DATE: July 24, 2015
TO: Zoning Committee
FROM: Jake Reilly, Planning Staff, 651-266-6618
RE: Zoning File #15-134-559 – Taco Bell/Border Foods

Background

The applicant, Border Foods, intends to demolish the existing Taco Bell restaurant at 565 Snelling Avenue North and construct a new Taco Bell restaurant at the same location, but with a different site plan. Per a decision by the Zoning Administrator, this triggers the requirement for a new conditional use permit application. The configuration of the drive-through and traffic flow will change, as will the number of parking spaces, and the location of the structure on the property. The applicant seeks a conditional use permit for a drive-through service lane, with a modification of the condition to allow the drive-through lanes to be closer than 60 feet to a residentially zoned or used structure and a conditional use permit to increase the maximum number of off-street parking spaces. The applicant also has applied for variances of minimum floor area ratio (0.5 required, 0.11 proposed), window and door openings as a percentage of front facade length (50% required, 47% proposed), and interior parking lot landscaping (15% required, 12

EXTERIOR ELEVATIONS

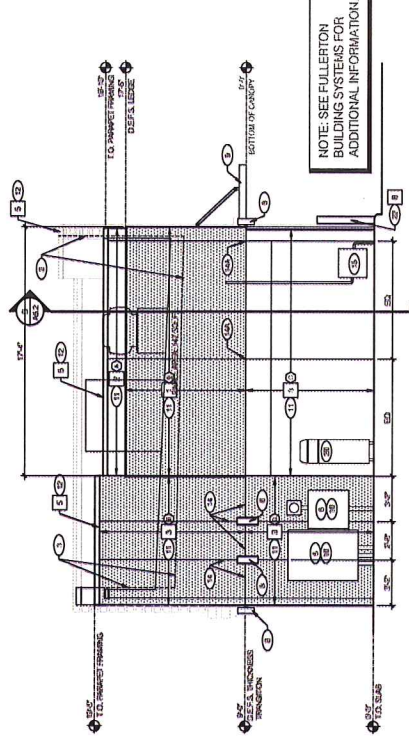
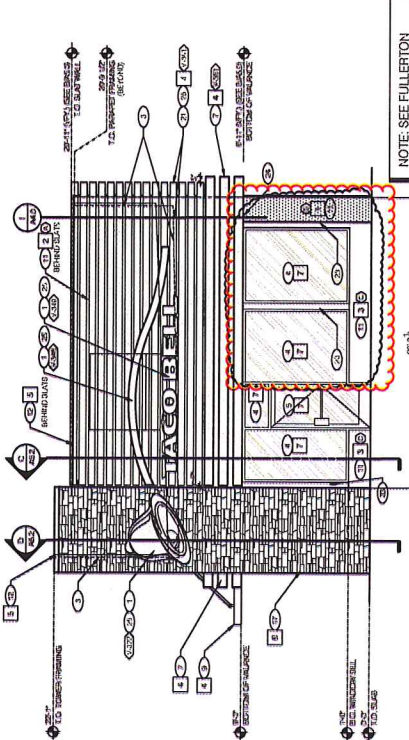
The standard for window and door openings is 50 percent of the façades facing a public street. The applicant's architect has provided new elevations demonstrating that the window and door openings on the sides of the structure facing a public street will be greater than 50 percent (51 percent), rather than the 47 percent proposed in the original application. This removes the requirement for the variance. The applicant has not yet withdrawn this variance application.

Should the committee wish to recommend approval, staff recommends mitigating the nuisance as much as possible through conditions as outlined above, and any other conditions considered reasonable; mitigating the request to increase the parking maximum by reducing the number of requested spaces from 20 to 18 which will have the effect of mitigating the request for a variance of interior landscaping requirement; and require that the new elevations featuring 51 percent window and door openings be substituted for the previous request.
